**WHITEMARSH TOWNSHIP
SHADE TREE COMMISSION MEETING AGENDA
JANUARY 6, 2026 AT 6:30 PM (IN-PERSON)**

- Grading Permit #2025-10 Green Valley Country Club R1 (201 Ridge Pike); Padel Court Location Change
- Grading Permit #2025-25 Madras Investments 1, LLC (400 Stenton Ave); Building Addition
- Grading Permit #2025-24 Union League Liberty Hill, LLC (800 Ridge Pike); Construction of New Ballroom and Associated Improvements

DRAWING NAME: EXISTING FEATURES PLAN
 UNION LEAGUE AT LIBERTY HILL - BALLROOM
 WHITEMARSH TOWNSHIP, MONTGOMERY COUNTY, PA
 LOCATION:

2 of 10

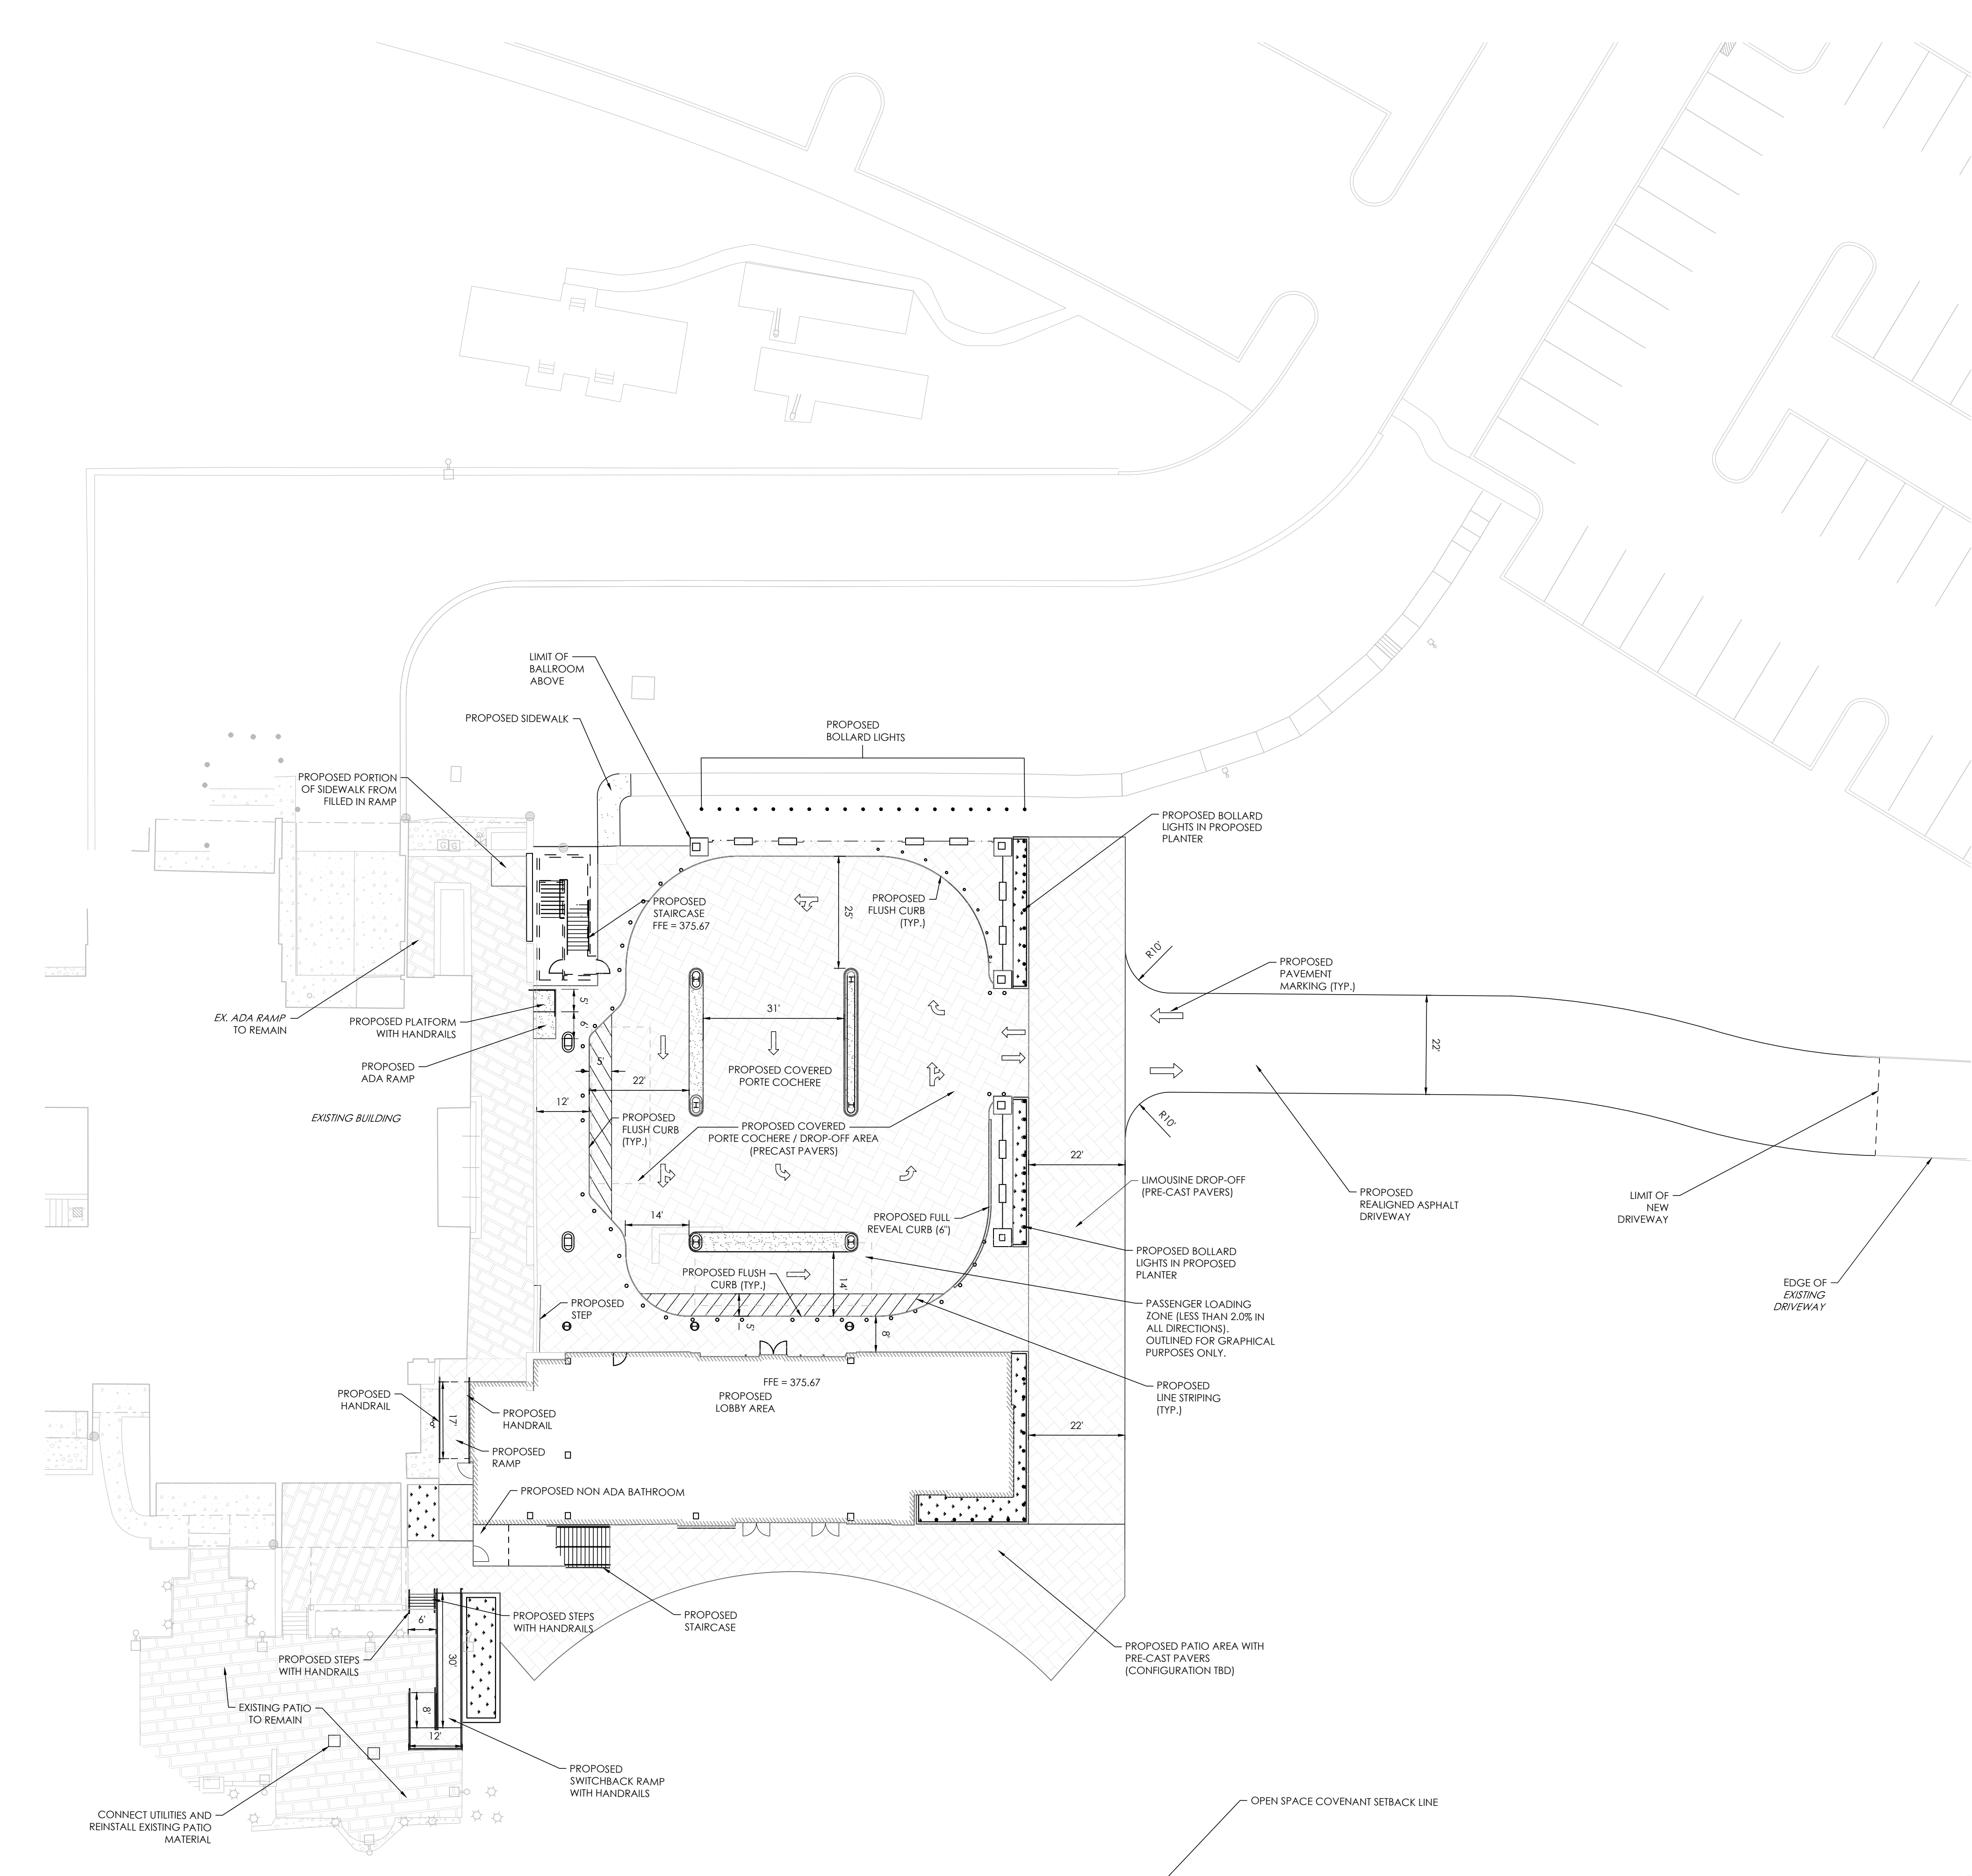
2. Show a detail for the township required chain link fence tree protection.
Response: After speaking with Ms. Samantha Zrillo via phone call it was confirmed that there is no PDF of a Tree Protection Fence Detail but there is a bulleted list in chapter 55 of the Whitemarsh Township code which lists the requirements for tree protection fencing. These requirements have been added to drawing sheet 2 of 10 and have been titled "Tree Protection and Preservation/ Protective Fencing Notes".

Response: We are now showing tree protection fence around the existing trees that are to be protected during construction on drawing sheet 2 of 10 and drawing sheet 8 of 10.

Response: We have added a table titled "Existing Trees Near L.O.D. to Be Protected" on drawing sheet 2 of 10 which lists the quantity, size, species, canopy/understory, and native/non-native.

Response: We have revised the table titled "Existing Trees to be Removed" on drawing sheet 2 of 10 to now list all of the required information for the existing trees that are proposed to be removed during construction. There is also a note below the table that reads "There are no trees within the limit of disturbance that will be preserved" for clarity.

1. Add a graphic tree protection detail to the plan set.
Response: We have added a detail titled “Chain Link Tree Protection Fence” on drawing C2.0 (sheet 2 of 10).
2. Provide a tree replacement plan or fee-in-lieu calculation consistent with Chapter 55.
Response: A partial waiver request has been submitted to the Shade Tree Commission on 11/26/2025 via email. Additionally, we have added a note titled “Waiver Requests” on drawing C1.0 (sheet 1 of 10) which states that we are requesting a partial waiver to

PROJECT NO: 2021-045.07
DATE: 10/31/2025
SCALE: 1" = 20'
SHEET NO: C8.0

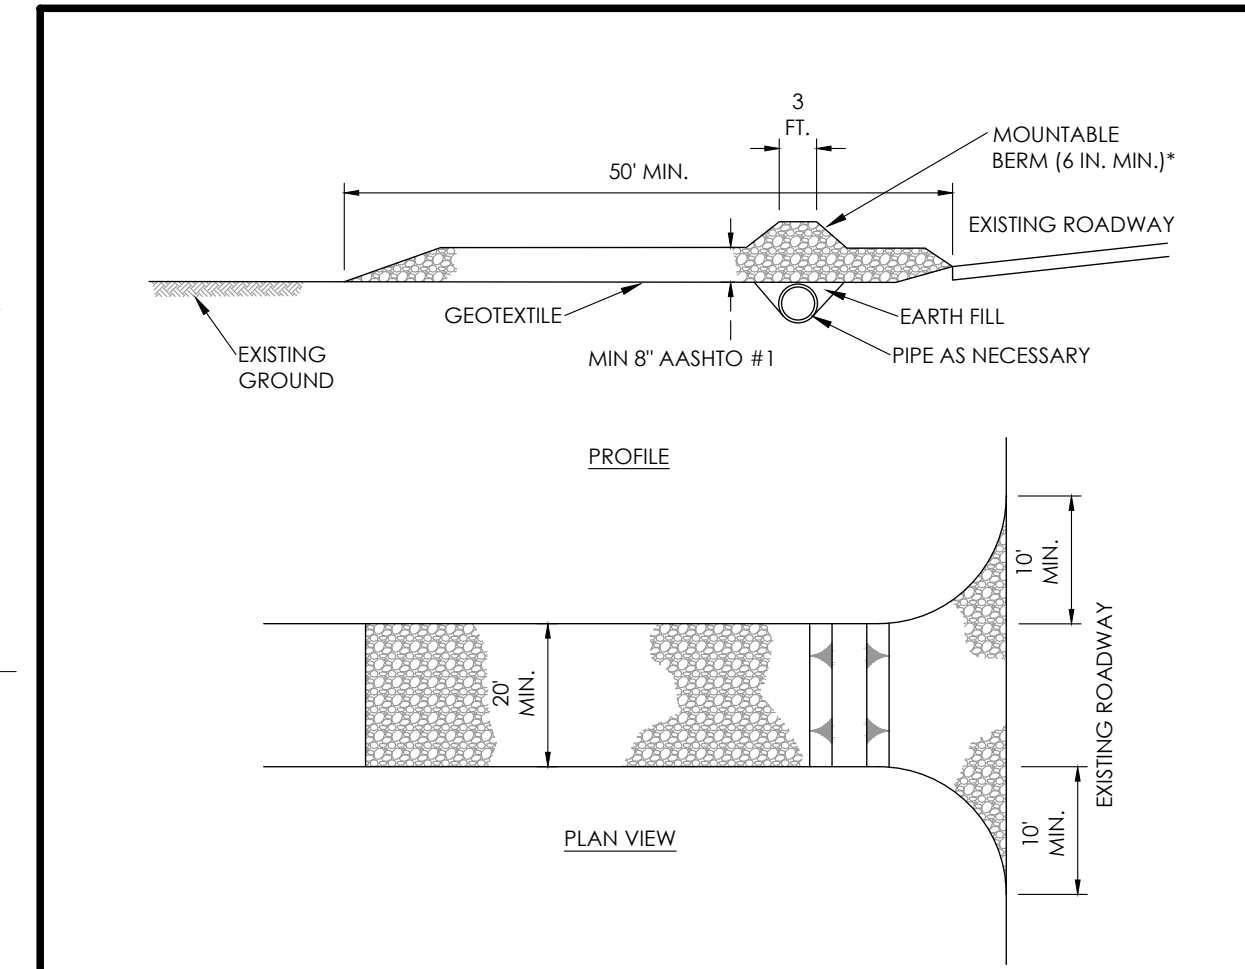
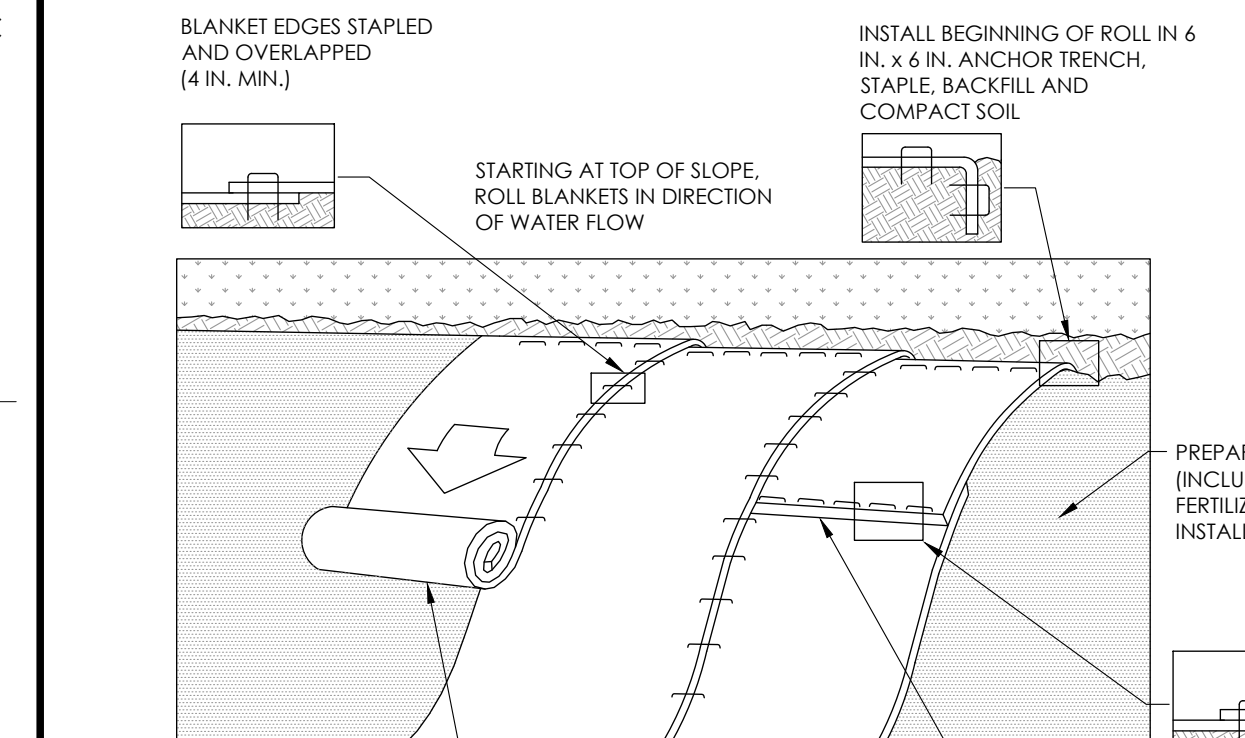
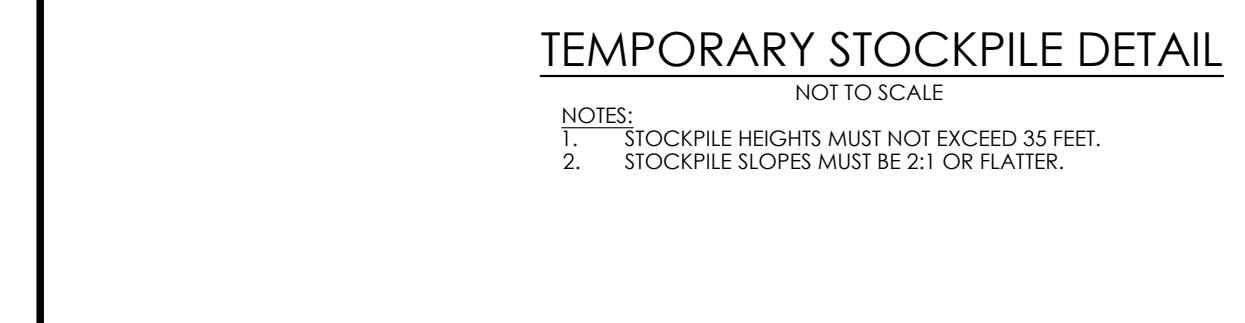
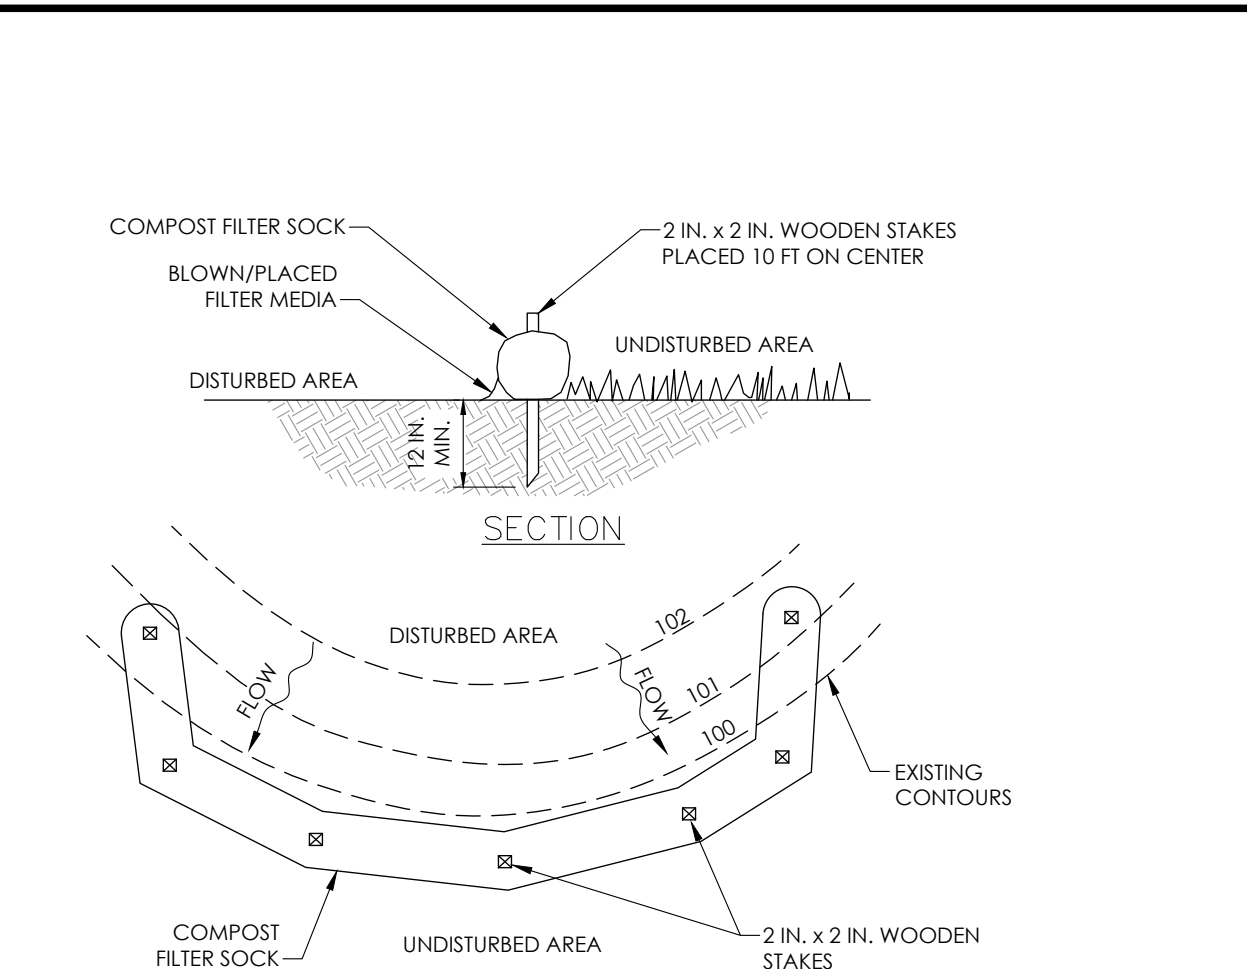
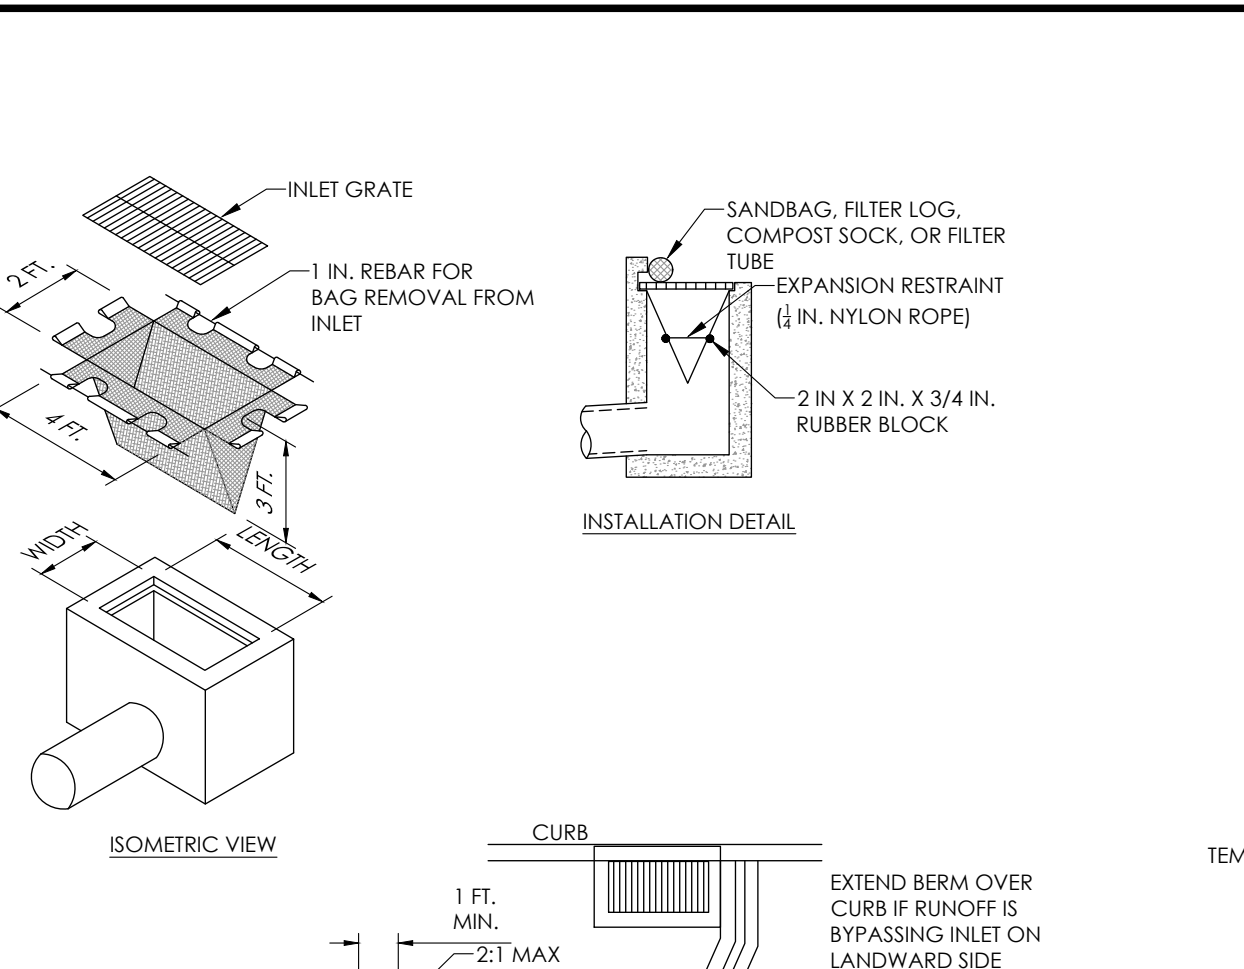
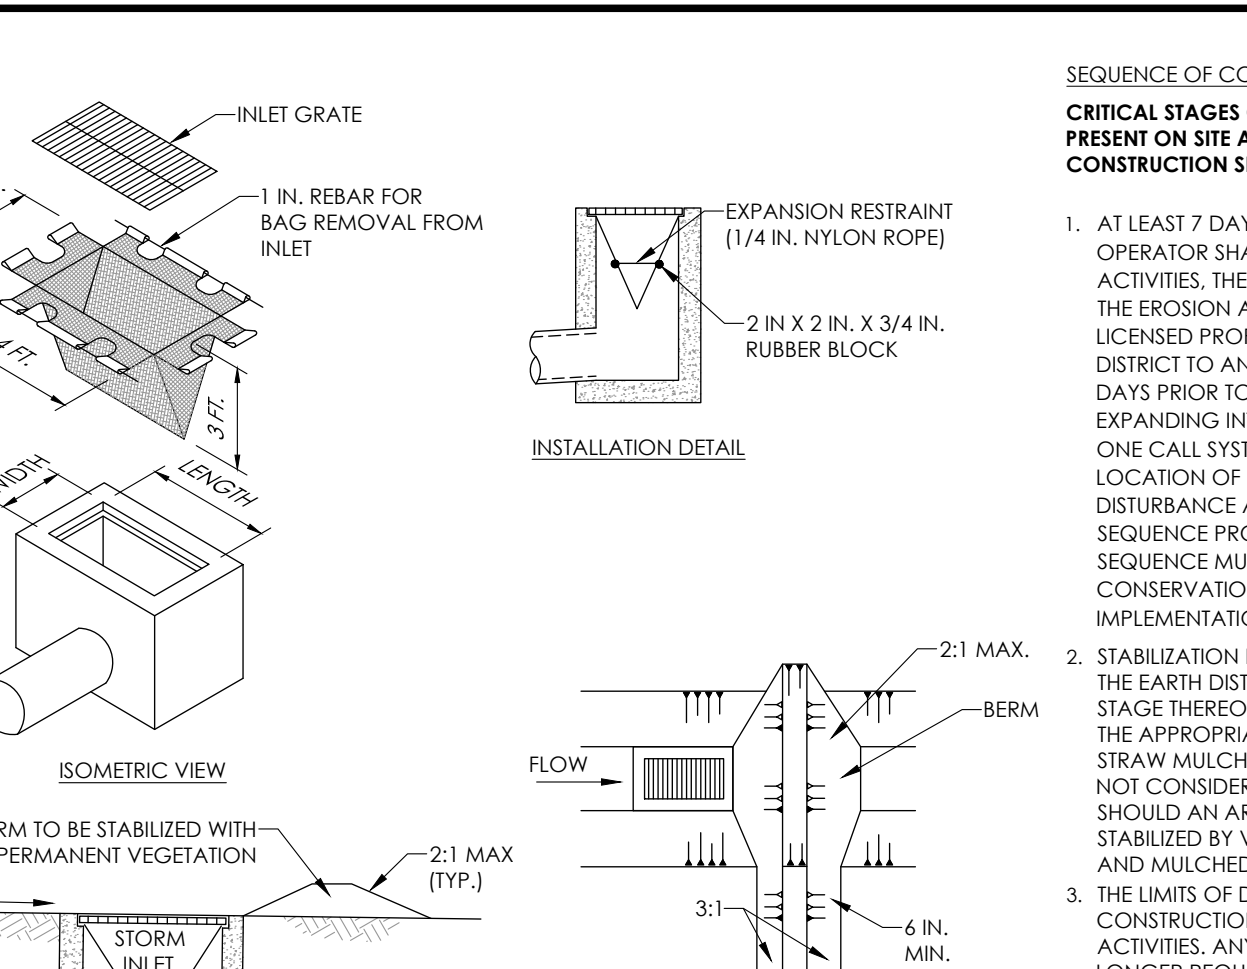
1. Show the tire wash location inside of the fence in construction zone.
Response: The proposed tire wash/ rock construction entrance is shown on drawing sheet C2.0 (sheet 2 of 10) and drawing sheet C8.0 (sheet 8 of 10) and it is within the proposed limit of disturbance. We have also added a concrete washout to both aforementioned drawing sheets and were sure to show it being a minimum of 100' away from all trees that we are proposing to protection with fencing.

We have added a second paragraph on drawing C8.0 (sheet 8 of 10) under the note section titled "Sediment Disposal" which includes all the "explicitly stated" information from Mr. Hosbach's 12/29/2025 review letter.

We are showing and calling out tree protection on drawings C2.0 (sheet 2 of 10) and C8.0 (sheet 8 of 10) as well as calling out tree protection fencing in these respective drawing's legends. We have also bolded sequence of construction note "4" which states that tree protection fencing must be installed prior to any work being conducted (grubbing, excavation, grading, trenching, cleaning, or installation of compost filter sock).
